MEMORANDUM TO THE LANDMARKS BOARD

September 9th, 2020

Landmark Alteration Certificate Request

Address: 1346 Pearl Street.
Owner: Reynolds Yew Tree LLC
Applicant: Wesley Stockton, STUDIO Architecture
Case Number: HIS2020-00210
Case Type: Landmark Alteration Certificate
Code Section: 9-11-18, B.R.C., 1981

Figure 12. Existing & Proposed northeast corner (façade).

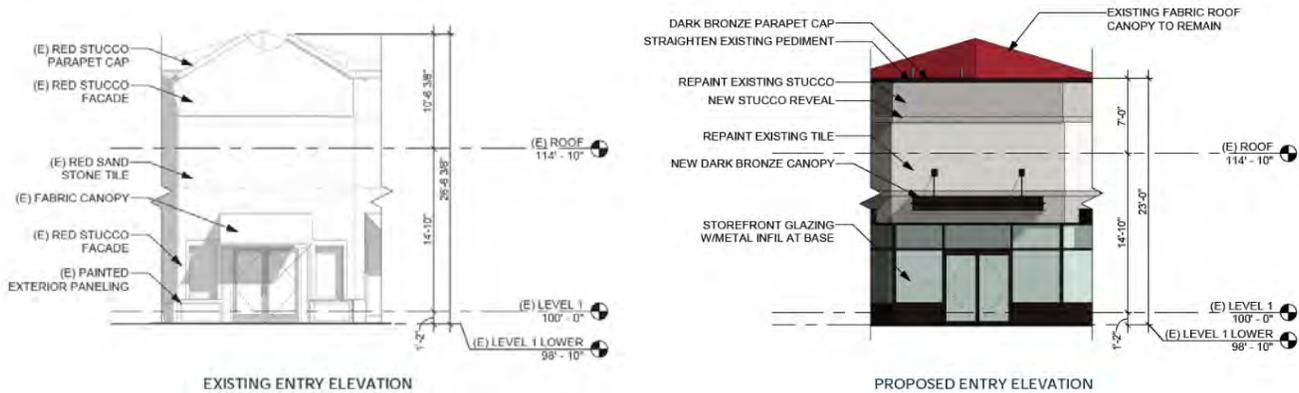
- Existing chamfered corner retained with new storefront system including double-doors, transom windows, black metal bulkhead and suspended canopy over doorway;
- Broken pediment feature shown to be removed and lowering of parapet 3', 6" to 23' in height from street level;
- Repainted stucco shown to remain at parapet level with existing wall tile also retained and repainted in lighter gray tone.

- A. Use of Traditional & Durable Materials** - Consideration should be given to possibility of removing stucco and tile (especially at focal corner entry), removing paint from original brick, and construction entire south wall of brick, to provide for more traditional and substantial materials. Resolve at the Ldrc.

- C. Awnings** - Suspended canopies and awnings are proposed. Review details at the Ldrc.
- D. Colors/Materials** - Consider removing paint from existing brick (using non-destructive method) to expose original texture & color. Likewise, explore materiality and color at N.E. corner, Pearl Street and at west end of Lowry Lane. Resolve at the Ldrc.

- a. Revise design to explore more traditional wall materials (including brick) at the north elevation, northeast corner, and north end of the east elevation and south face of building facing onto Lowry Lane;

Figure 14. Proposed North Elevation.

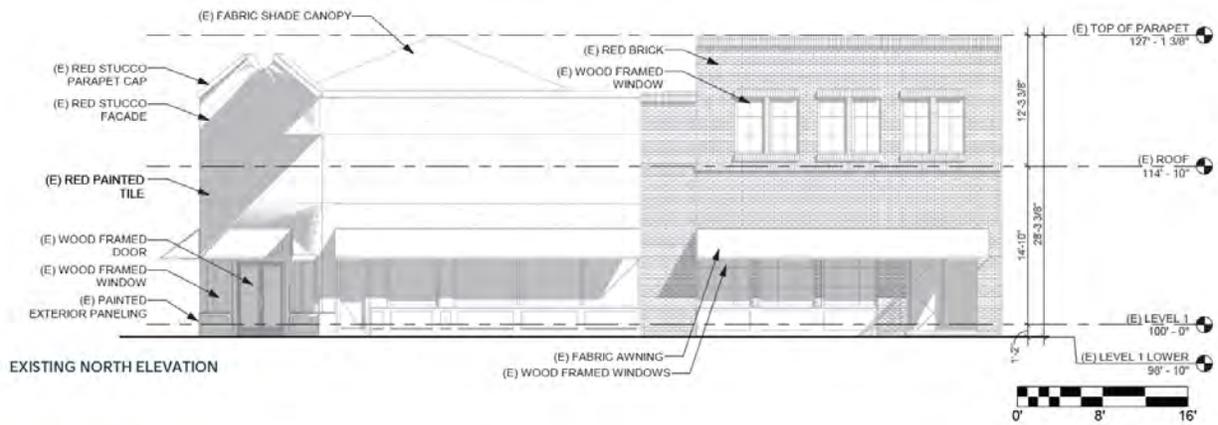
- West (brick faced) portion of north face shown to be unchanged with exception of new fabric awning;
- East portion (30' exposure) of storefront shows new glazing system matching that at the northeast corner with same repainting of stucco and tile areas above suspended canopy;
- New bronze finish gooseneck lighting proposed.

Figure 16. Proposed East Elevation.

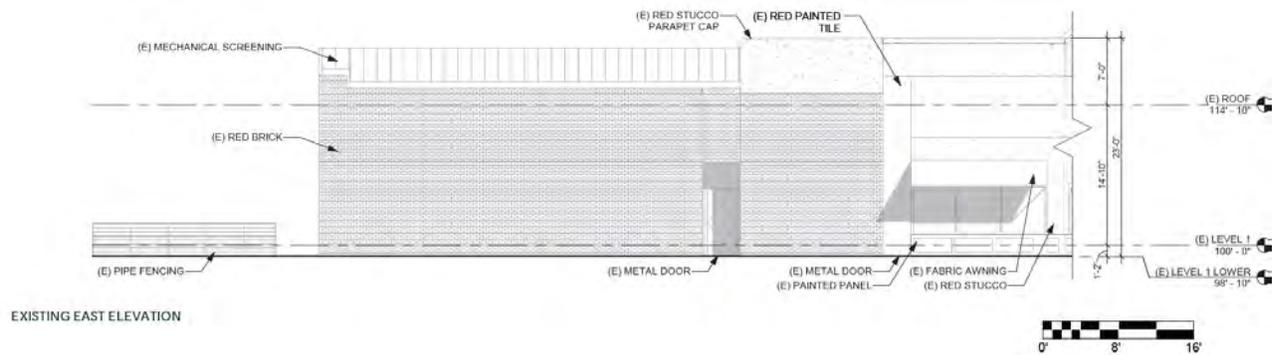
- Northern portion of storefront proposed to increase from existing 20' width to a 30' exposure maintaining a 30' height for that expanse with storefront window system, canopy, and painted stucco and tile finish the same as proposed at chamfered corner;
- Middle portion of east face shown to be approximately 45' in width and maintaining the existing 18' high painted brick wall with three punched, 12' wide storefront three-light window systems with awnings;
- The 35' wide south portion of the east wall is shown to be new construction faced with brick stepping up to about 23' in height and featuring three pilasters and neo-traditional decorative masonry elements;
- The south portion of the east face is divided into two bays each with a three-light storefront system, suspended canopies and three gooseneck lighting.

- F. Storefront Rhythm** - Original mid-century building is low and horizontal and this is refelected in the central portion of the east face which is broken into three bays. Consider providing entrance(s) on this expanse and aligning storefronts which appear offset to north. Resolve at the Ldrc.

- B. Size, Shape, and Proportion of Storefronts** - Current proposal activates 14th Street with storefronts. Refine to explore providing entrances on 14th Street and further articulating alley face. Resolve at the Ldrc.

- b. Revise design to center bays, include storefront entrance(s), and remove paint from exterior brick wall central portion of east elevation facing onto 14th Street;

Figure 18. Proposed South (Alley) Elevation.

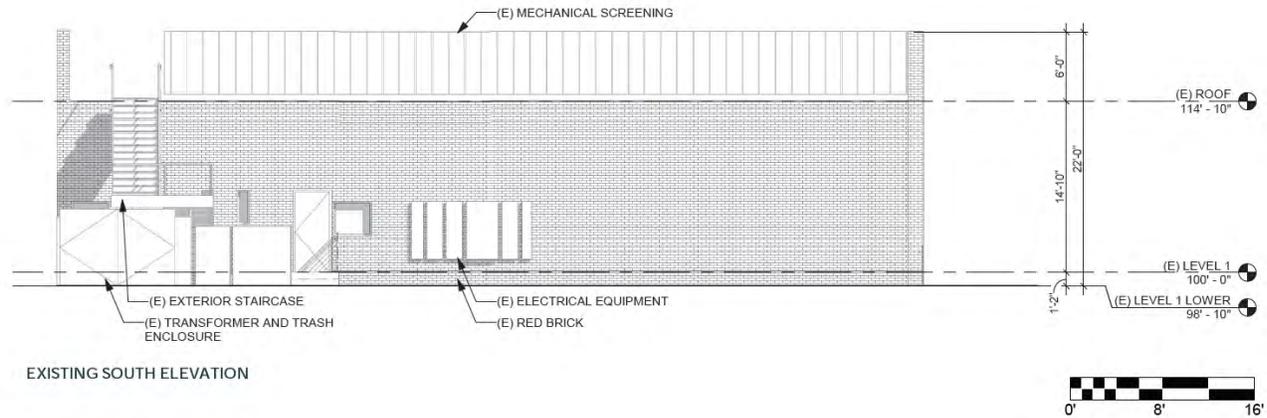
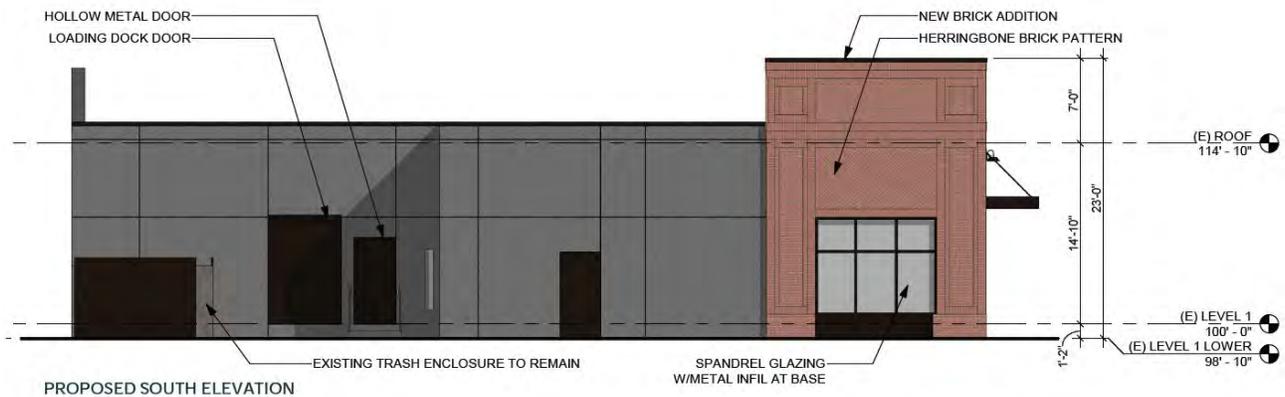
- The existing south wall is shown to be deconstructed and a new south face constructed along the rear setback at Lowry Lane approximately 35' south;
- Elevations show the eastern portion of the new wall to be approximately 23' in height, constructed of brick with decorative elements continuing the motif of the east wall with a single, three-light storefront to match others proposed;
- The 58' of the proposed south wall (the west portion of which is shown to be inset 10') is shown to be approximately 18' high, finished in stucco and to include two service doors, a loading dock and trash enclosure.

- E. Design on all Exposed Elevations** - Southeast corner of brick addition turns west with storefront exposure onto Lowry Lane. Remaining expanse of south wall along alley lacks architectural articulation. Consider providing more architectural interest on south to enliven alley. Resolve at the Ldrc.

- E. Improve Rear & Side Elevations** – Consider providing more architectural interest on south to enliven alley. Resolve at the Ldrc.

- c. Enhance architectural articulation at west portions of south wall (possibly by constructing of brick) and explore providing additional storefront entrance(s) onto the alley;
